Source: CT3
Title: CR to Rel-6 related to NI upgrade on Work Item SCUDIF
Agenda item: 9.25
Document for: APPROVAL

CHANGE REQUEST

23.172 CR 040 # rev 4 # Current version: 6.2.0

Title:	# Network-Initiated upgrade procedure for SCUDIF		
Source:	# Nokia, Orange, Ericsson, Siemens, Vodafone, Nortel		
Work item code:	# SCUDIF	Date:	# 25/04/2005
Category:	# F	Release:	# Rel-6
	Use <u>one</u> of the following categories:		Use <u>one</u> of the following releases:
	F (correction)		Ph2 (GSM Phase 2)
	A (corresponds to a correction in an earlier release)		R96 (Release 1996)
	B (addition of feature),		R97 (Release 1997)
	C (functional modification of feature)		R98 (Release 1998)
	D (editorial modification)		R99 (Release 1999)
	Detailed explanations of the above categories can be found in 3GPP TR 21.900 .		Rel-4 (Release 4)
			Rel-5 (Release 5)
			Rel-6 (Release 6)
			Rel-7 (Release 7)

Figure 4.14c1: Network-Initiated Service change from speech to multimedia requested, accepted

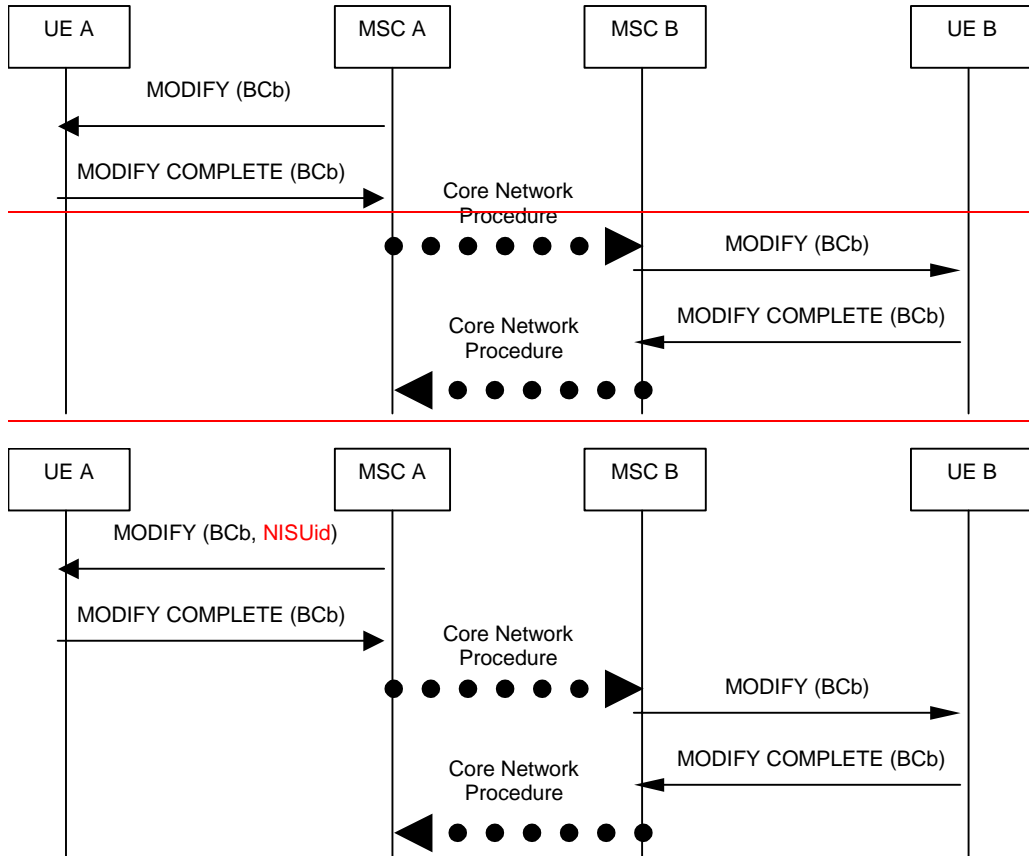
If the visited MSC is again able to support the multimedia at a later point in time while the speech call is still ongoing, the same visited MSC may initiate a service change from speech to multimedia as stated in TS 22.101 [8]. The details for the service change from speech to multimedia are [described in section 4.2.5.2.FFS](#).

[For a downgrade from multimedia to speech](#) ¶The visited MSC shall initiate an In-Call Modification procedure towards the terminal it serves using the MODIFY message. The visited MSC shall also invoke the service change procedure (see clause 4.3.5) towards the remote side. The terminals on both sides will react as described in Clause 4.2.4. [An MSC shall only perform a Network Initiated Service Upgrade from speech to multimedia if the terminal has indicated support for Network Initiated Service Upgrade Capability during the call establishment phase, as detailed in 3GPP TS 24.008 \[3\]. When sending the Modify request to the local terminal the MSC shall include the Network-initiated Service Upgrade indicator.](#)

Figure 4.14c2: Network-Initiated Service change from speech to multimedia requested, rejected by user A

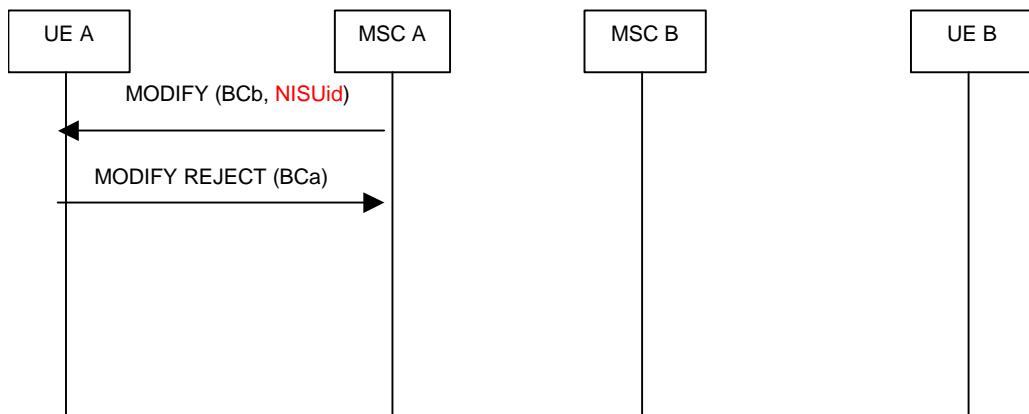
If the served terminal rejects the service change from speech to multimedia, the- initiating MSC shall maintain the original service. If the remote side rejects the service change from speech to multimedia, the initiating -MSC shall initiate a service change procedure towards the served terminal to revert to the original service.

Figure 4.2.5.2/1: Network-Initiated Service change from UTRAN speech to multimedia requested, accepted in case the RAB is modified on the initiating side after receiving the response to the service change request from the remote side

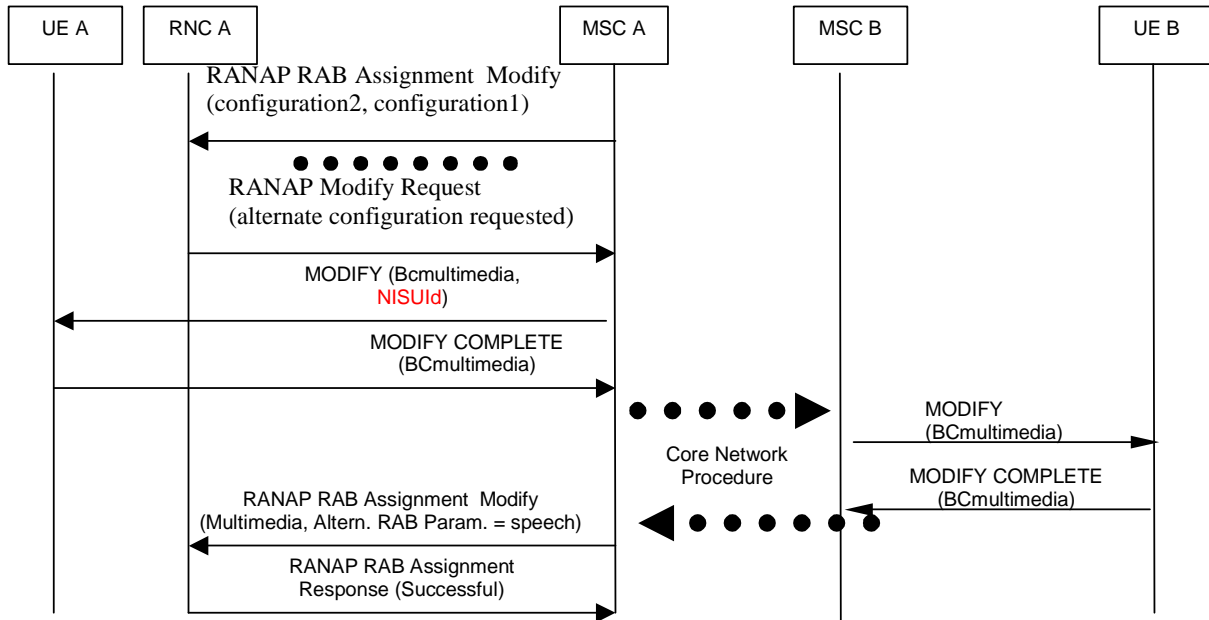
When the radio access network later detects that there are sufficient resources to sustain again the multimedia RAB configuration, it shall indicate the possibility of a service change to the alternative multimedia RAB configuration by sending a RANAP Modify Request message (see 3GPP TS 25.413 [17]) to the MSC. The MSC may then:

- initiate an In-Call Modification procedure to multimedia towards the terminal it serves using the MODIFY message. The visited MSC shall include the NISUId information element in the MODIFY message. The MSC initiating the service change shall not interrupt the user plane until the terminal accepts the modification with a MODIFY COMPLETE message. When the MODIFY COMPLETE message is received from the served terminal, the initiating MSC shall then:
- invoke the service change procedure (see clause 4.3.5) towards the remote side. The initiating MSC shall then:
- reconfigure the RAB to the multimedia bearer at the latest when receiving a confirmation about the successful service change procedure from the remote side.

Figure 4.2.5.2/7: Alternative RAB Parameters delivery during the relocation

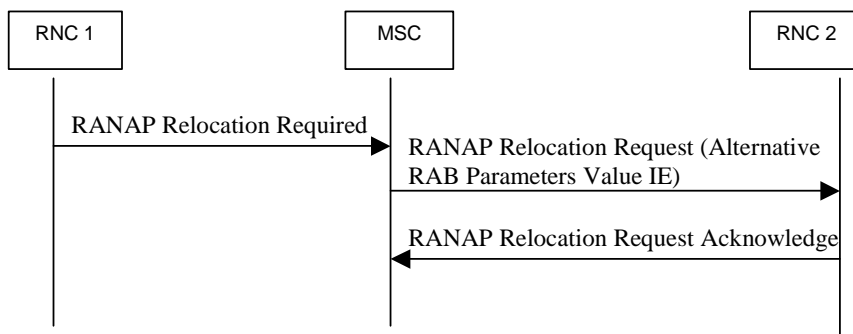
In order to request a notification about sufficient resources to sustain again the multimedia RAB configuration from the radio access network, the visited MSC shall include an Alternative RAB Parameters IE in the RANAP RAB Assignment Request or RANAP Relocation Request message indicating the RAB configuration for multimedia in addition to the RAB configuration for speech, when it establishes or modifies the radio access bearer for speech at the Iu interface during or after a network-initiated service change from multimedia to speech. In order to request a notification about sufficient resources from a target RNC after a subsequent relocation, the MSC shall pass the Alternative RAB Parameters IE in the RELOCATION REQUEST message to the target RNC.

Figure 4.3.5.1/8: Network-initiated service change speech to MuMe (continued)

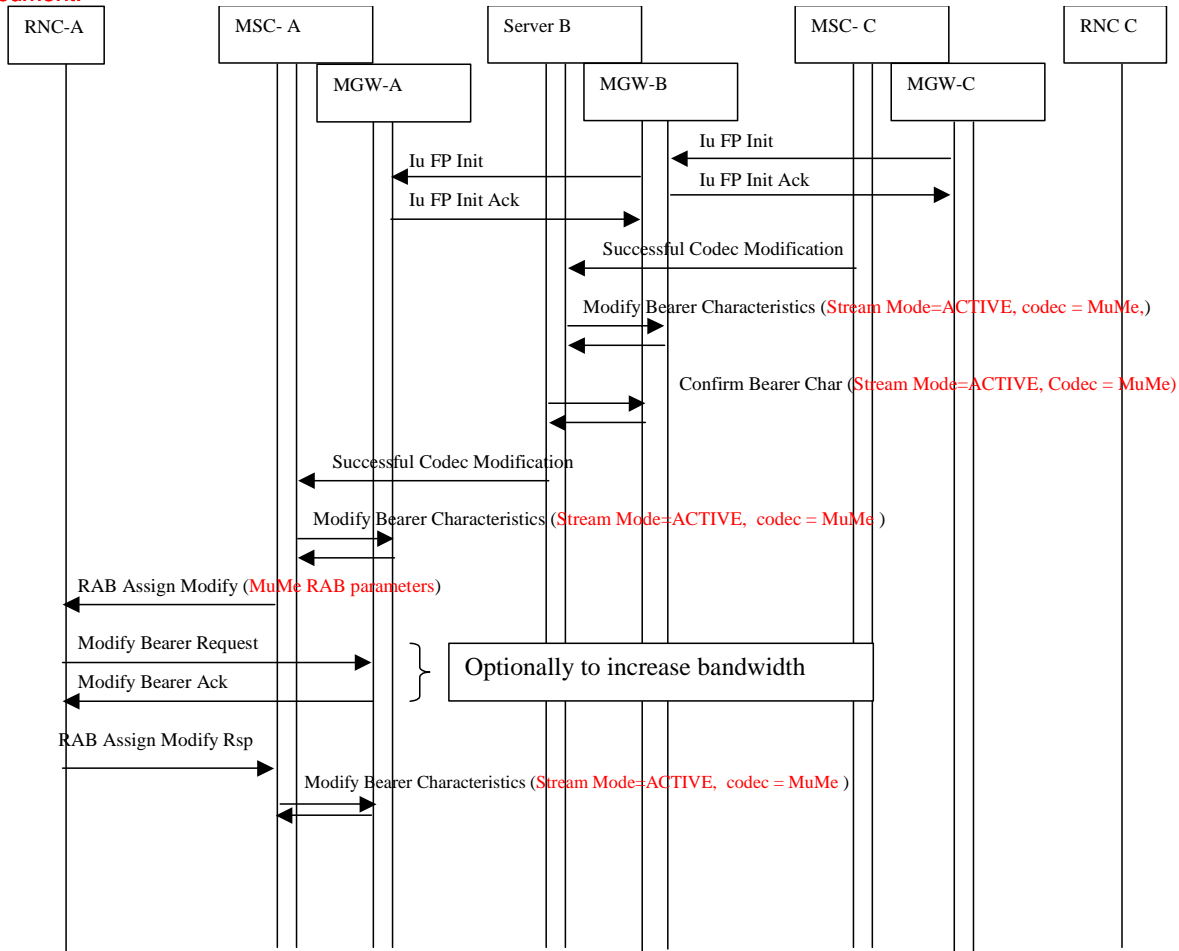
NOTE: The RAB Assign Modify sent towards RNC-A may also be sent by MSC-A before receiving the Successful Codec Modification Message.
